**Before the
FEDERAL COMMUNICATIONS COMMISSION
Washington, D.C. 20554**

In the Matter of)	
)	
Advanced Television Systems)	MM Docket No. 87-268
and Their Impact Upon the)	
Existing Television Broadcast)	Petition for Reconsideration
Service)	of Hammett & Edison, Inc.
)

Summary

The firm of Hammett & Edison, Inc., respectfully submits this Petition for Reconsideration regarding issues in the Fifth and Sixth Reports and Orders to MM Docket 87-268, concerning the new advanced digital television (“DTV”) service.

Calculated KFMB-TV NTSC Interference to KABC-TV DTV
Plus Longley-Rice Error Cell Locations
Determined Using FCC Algorithms

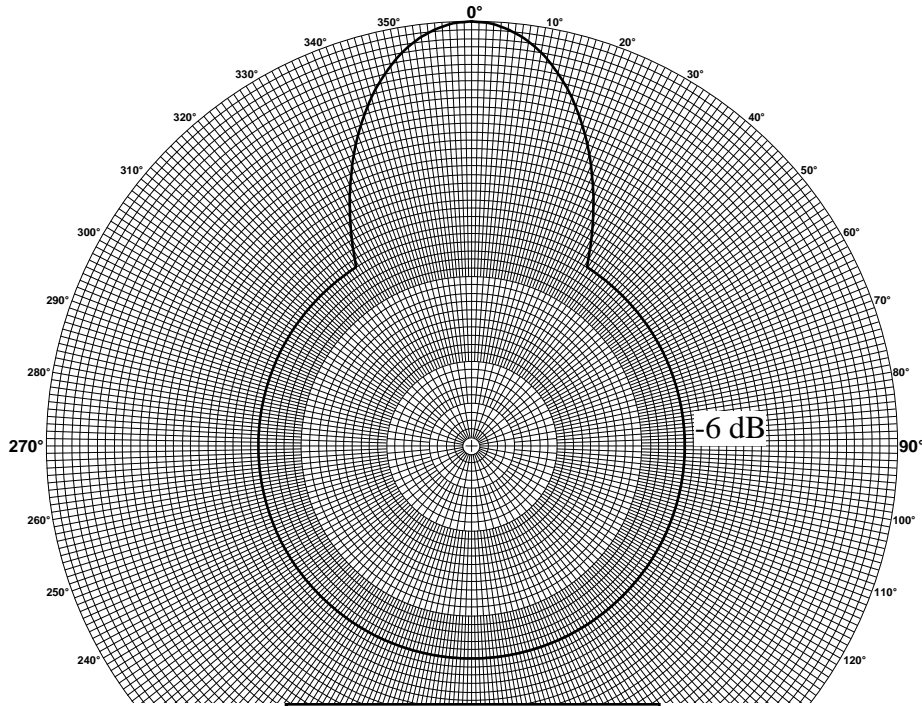
8. While this assumption appears not to introduce significant overall errors in areas of relatively flat terrain, it has been found that the error code is returned much more often for studies involving mountainous or even hilly terrain. For example, the attached Figure 2 shows predicted interference to the coverage area of the DTV Channel 8 allocation assigned to Station KABC-TV, Los Angeles, from the existing NTSC transmitting facilities of Station KFMB-TV, Channel 8, San Diego, California. While the FCC DTV analysis returned a result of interference to nearly 294,000 persons, it simply ignored possible interference to over 1.1 million persons within the KABC-TV DTV coverage area, due to Longley-Rice errors, considering all of that area to be “interference-free.”

to be studied. This effect is illustrated on attached Figure 2, which shows the truncation in the northern area of the station's Grade B contour, and shows that there may be areas of further interference within the Grade B contour that have not even been checked, leading to further exaggeration of the degree of replication.

Different Consumer Receive Antenna Patterns, as Assumed
by FCC "Replication" Program to Develop DTV Allotments
– Low-Band VHF –

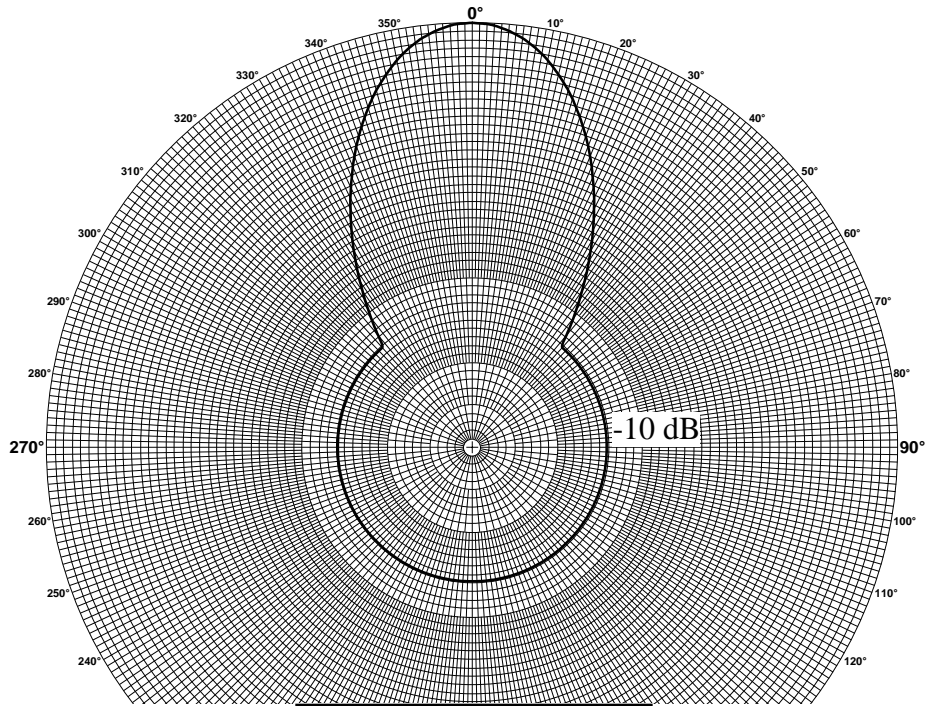
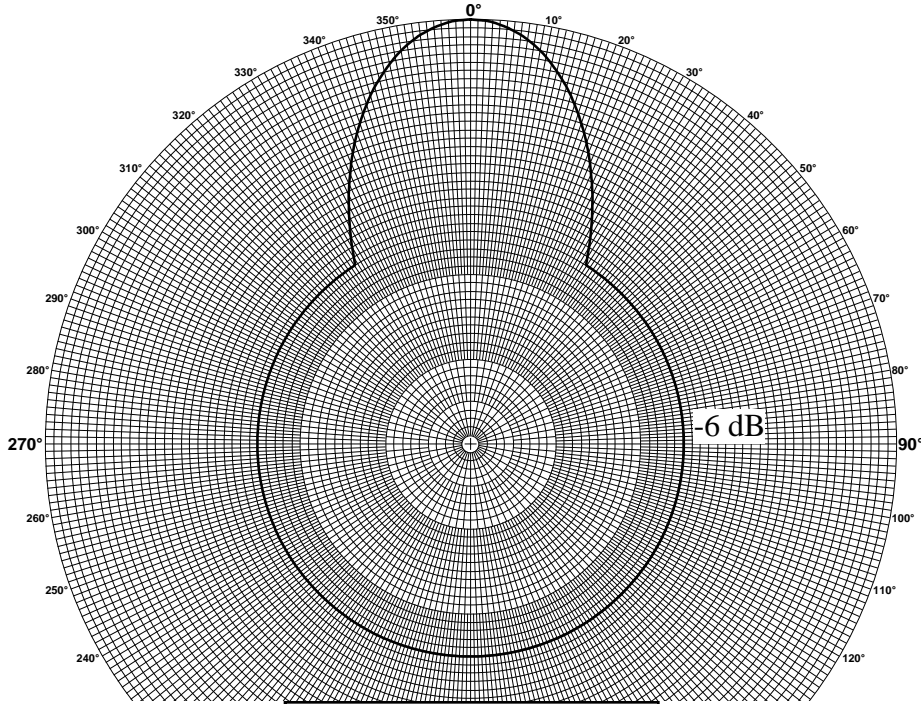
10. The DTV replication program assumed that the consumer antennas used for reception of the DTV signals would be better-performing than the ones used for reception of the NTSC signals, despite the fact that both operations are on the same general frequencies and that no one, in fact, had suggested that consumers would be at all inclined to replace their existing antennas or to install second, larger antennas just for DTV. Evidently, these alternate patterns, included as Figure 3, proved necessary in order to achieve the desired replication numbers. The off-axis rejections (front-to-back ratios) of the DTV antennas are higher, as follows:

However, such antennas would not necessarily be purchased and installed by consumers viewing the DTV stations off-air. In fact, a more reasonable assumption is that they will *not*. Therefore, DTV service will be more interference-limited than assumed and the replication of service will not, in practice, be achieved.
